TECHNICAL NOTE 1

LAND AT ROOK FARM, ST MARY'S ROAD
HAYLING ISLAND, HAMPSHIRE

Client: Gladman

1.2 Purpose of Report

P21033-001G

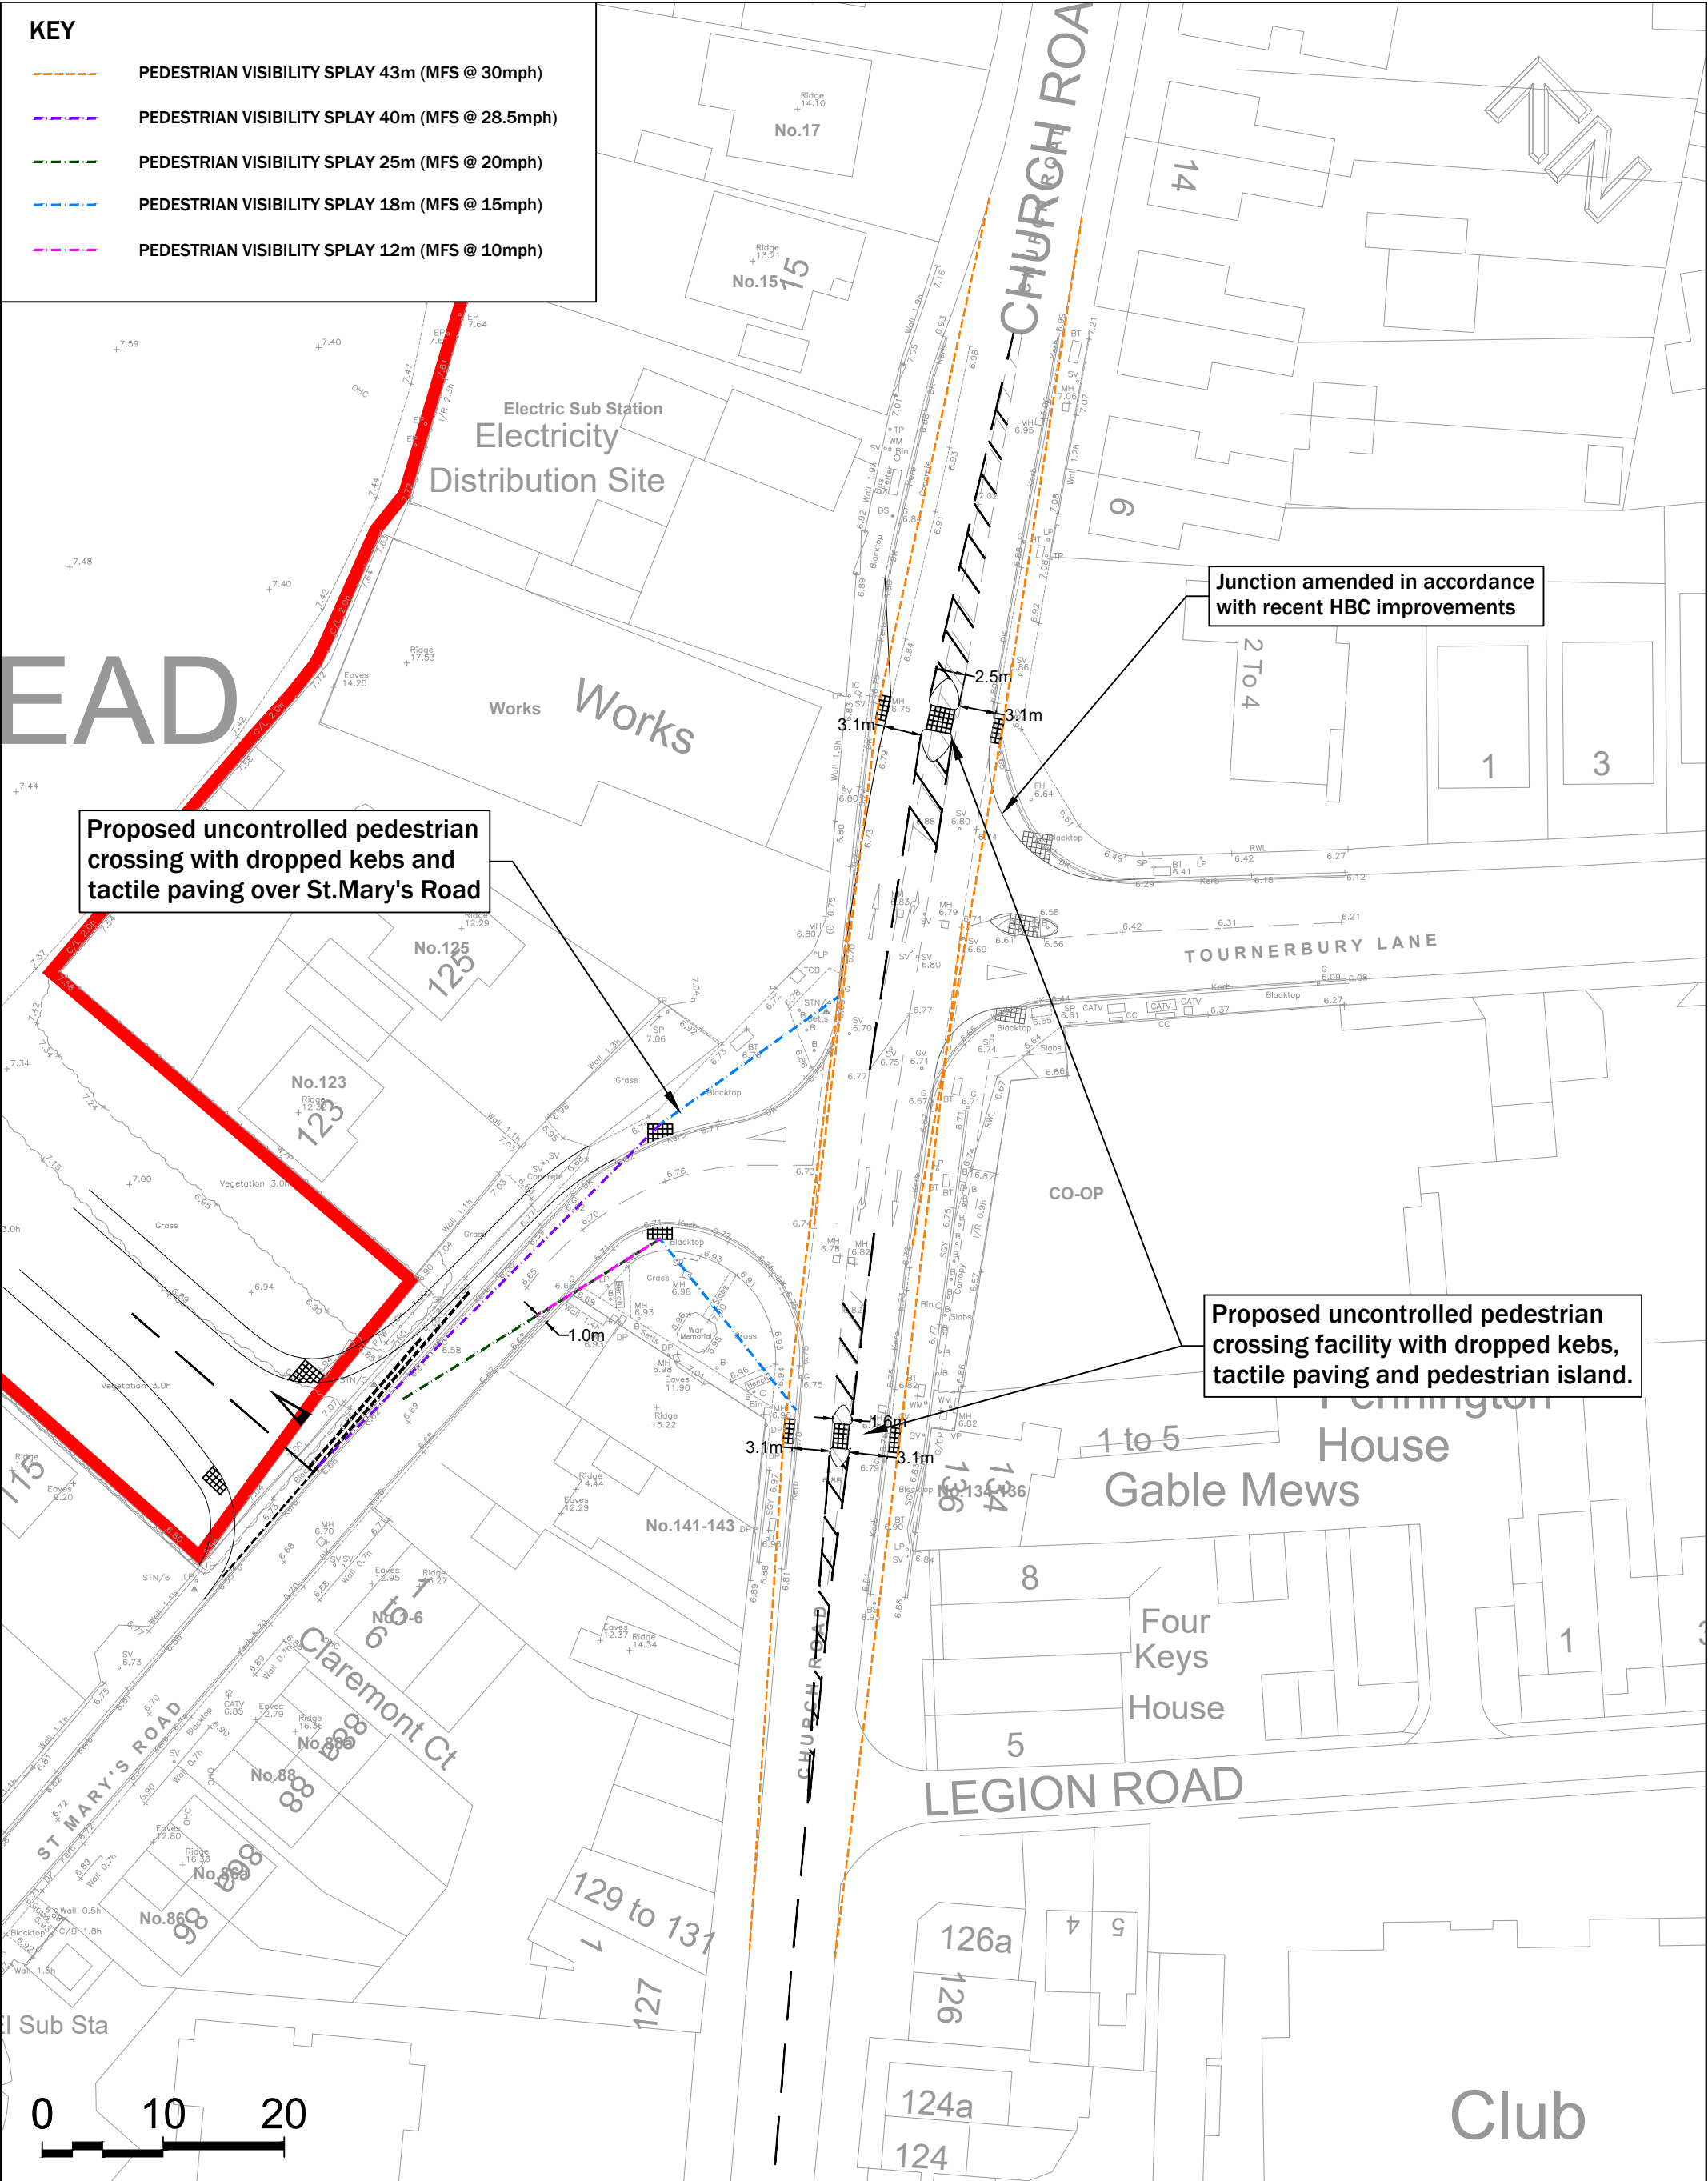
- 2.2.1 HCC acknowledged the use of speed surveys undertaken in August 2021 to derive site specific visibility splays. The authority has however taken the view that August is not a neutral month.

- 2.2.6 HCC has requested that refuse collection swept paths should be undertaken using a 11.2m long 'super large' refuse collection vehicle (RCV). It was also stated that the slightly shorter RCV was shown to overhang the centreline on St Mary's Road on approach to the site and within the bell-mouth.

- 2.2.4 The recorded speeds were slower than the signed speed limit and comparable to the previously used speeds, which were chosen given that they were more recent. The access drawing has however been updated based on these speeds and is provided as Drawing P21033-001G in Appendix 2. The visibility splays can be achieved without any third-party land.

- 2.2.7 Whilst such manoeuvres and extents of overhang are commonplace across the UK, we have increased some of the proposed site access geometry to better reduce the level of overhang. Drawing P21033-001G in Appendix 2 illustrates these changes with tapers added to both corners and the access slightly repositioned. Drawing P21033-003D in Appendix 2 presents the RCV swept paths using an 11.2m long vehicle. It shows that the amendments to the access reduce the level of overhang. The RCV still crosses the centreline on approach from the west but this is no different to the existing arrangement. The qualified RCV drivers will simply wait until oncoming traffic is clear, as they currently do and is common practice.

- 2.3.3 Given that the footpath is not essential to providing safe access between the site and local amenities, the footway provision is no longer proposed. Instead, an uncontrolled crossing consisting of dropped kerbs and tactile paving is proposed across St Mary's Road from the existing footway on the northern side to the footway on the southern side immediately east of the public car park access. This is shown on Drawing P21033-001G.

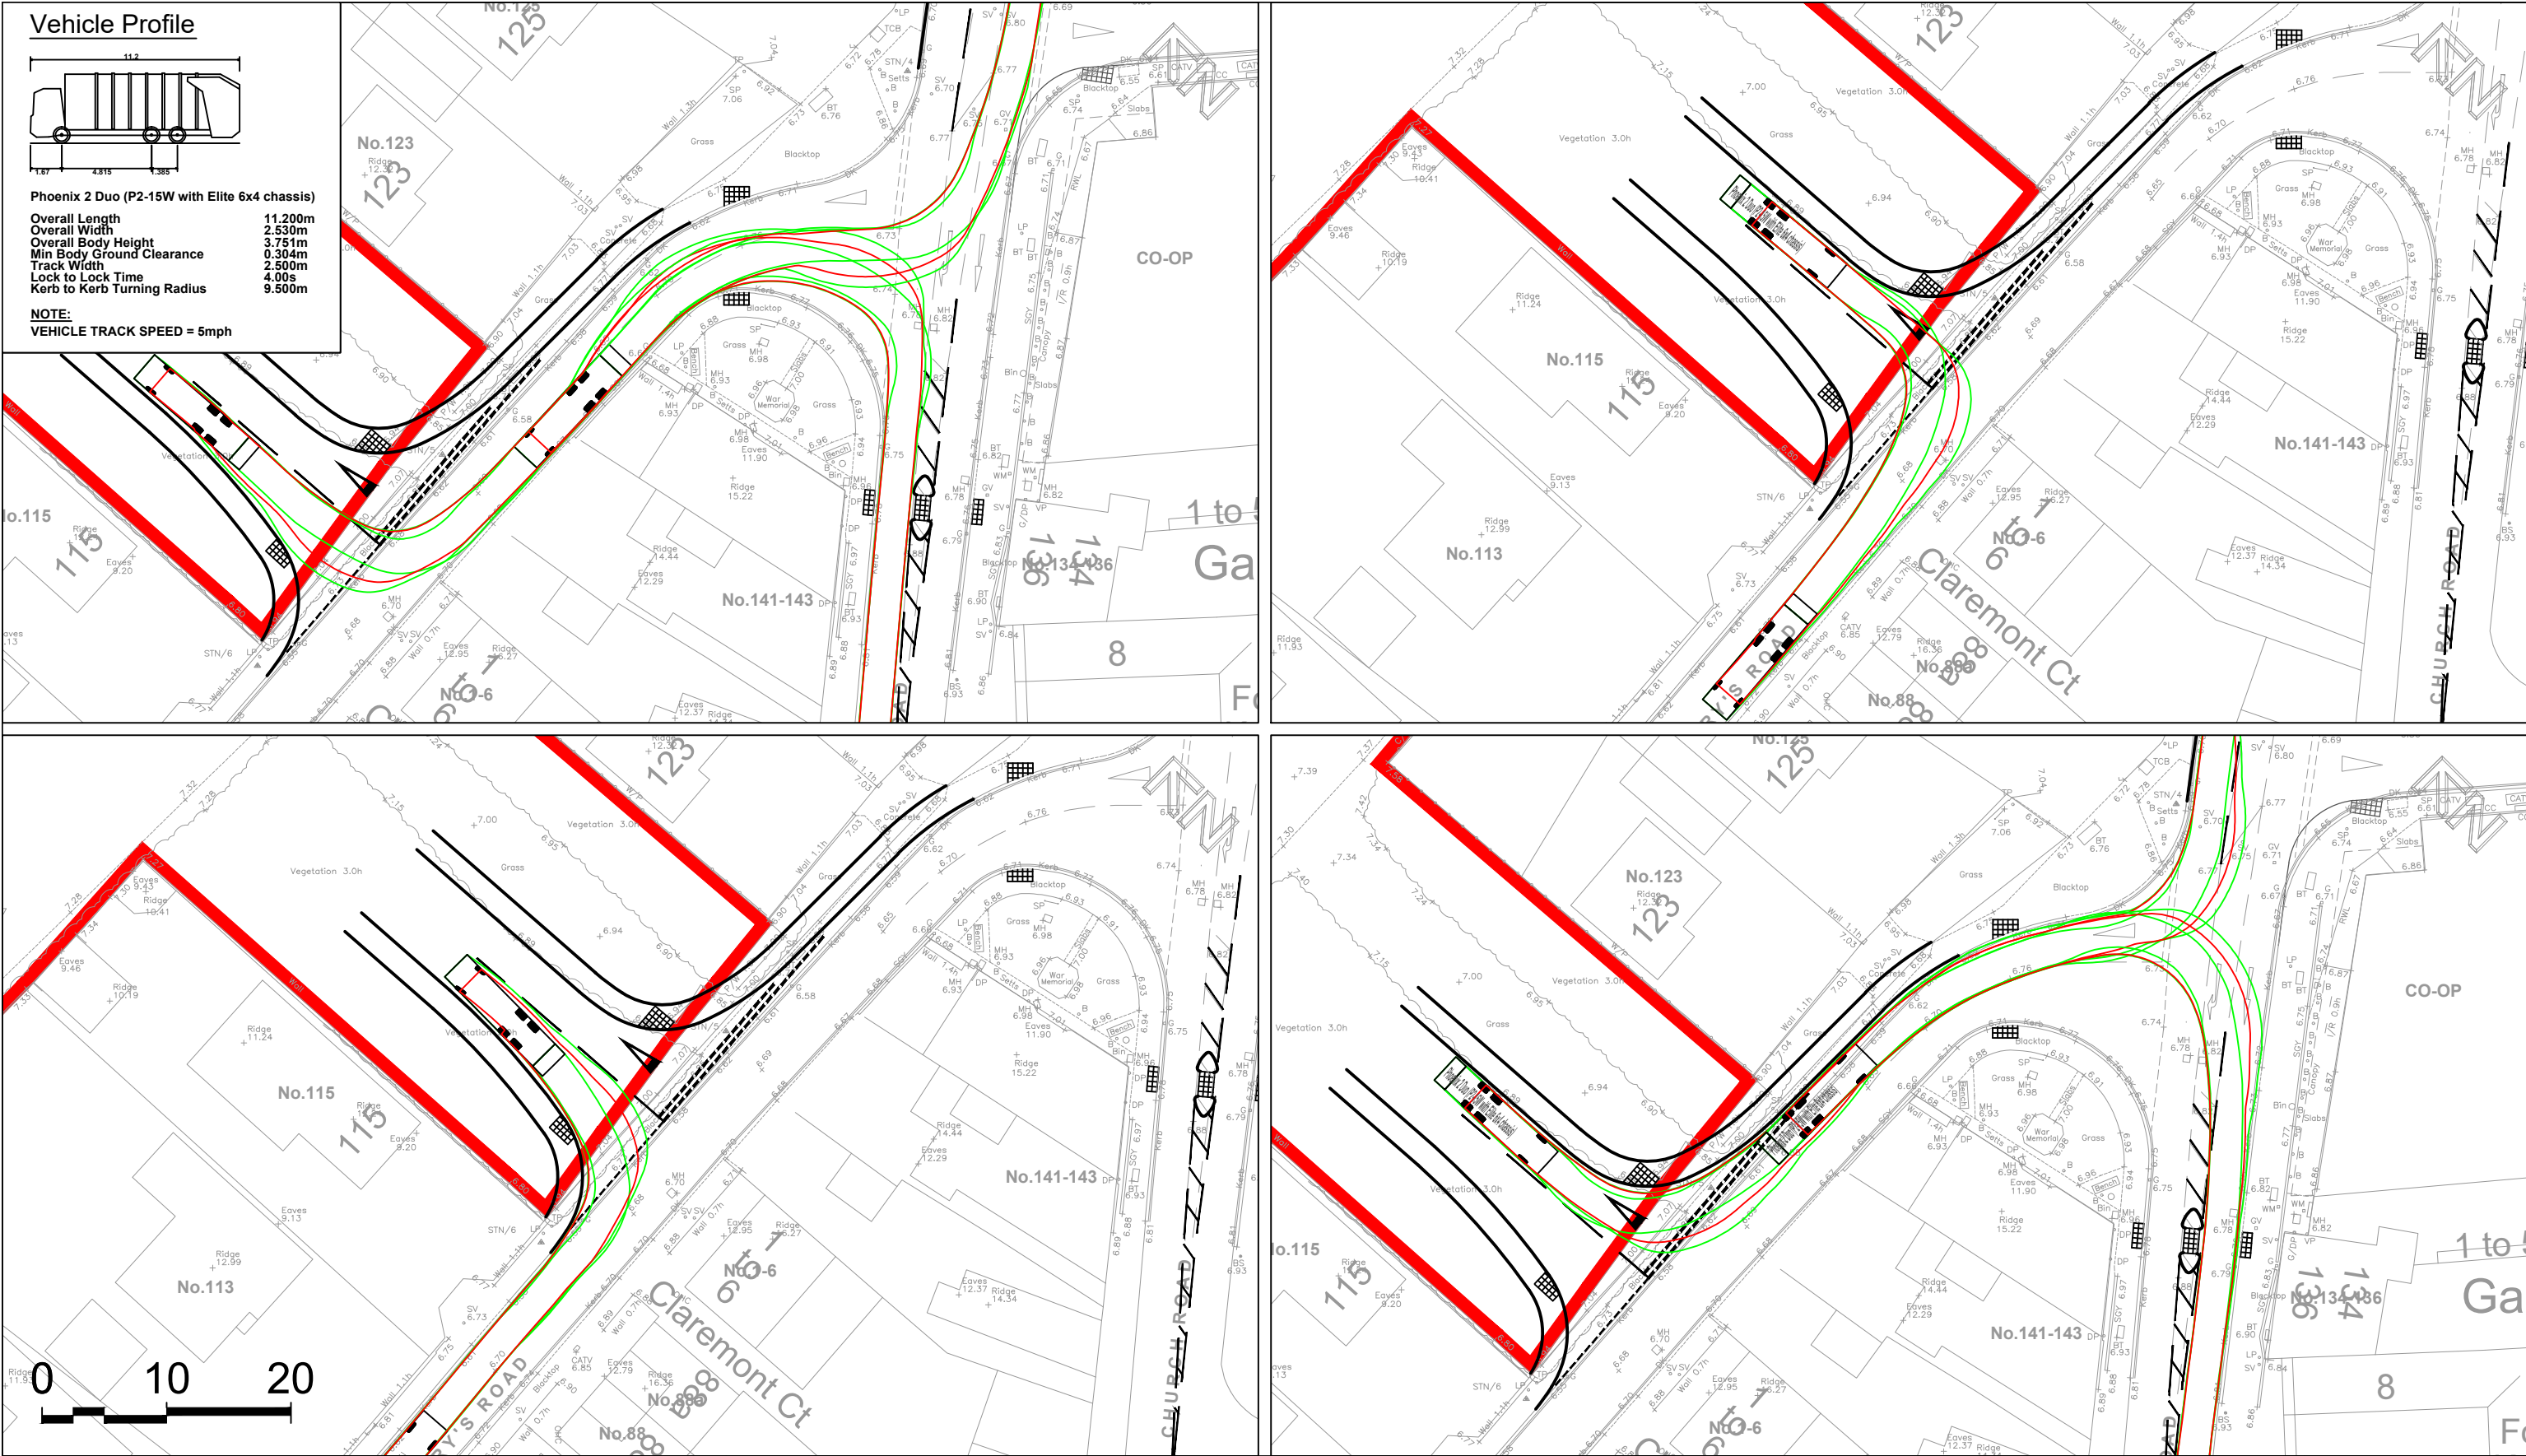
- 2.3.8 HCC has raised concerns related to the bus stop swept path analysis and the lane and island widths at the proposed pedestrian crossings on Church Road and Elm Grove, particularly in relation to *LTN 1/20 Cycle Infrastructure Design* guidance.
- 2.3.9 Amendments have been made to bring the proposals in line with LTN 1/20 as shown in Drawing P21033-002D in Appendix 2. The carriageway each side of the two proposed pedestrian refuge islands has been reduced to 3.1m, the northern island increased to 2.5m and the southern island increased to 1.6m. Aside from being in line with the guidance and therefore safer for cyclists, the narrowing of the carriageway adjacent to the islands will have added traffic calming benefits.
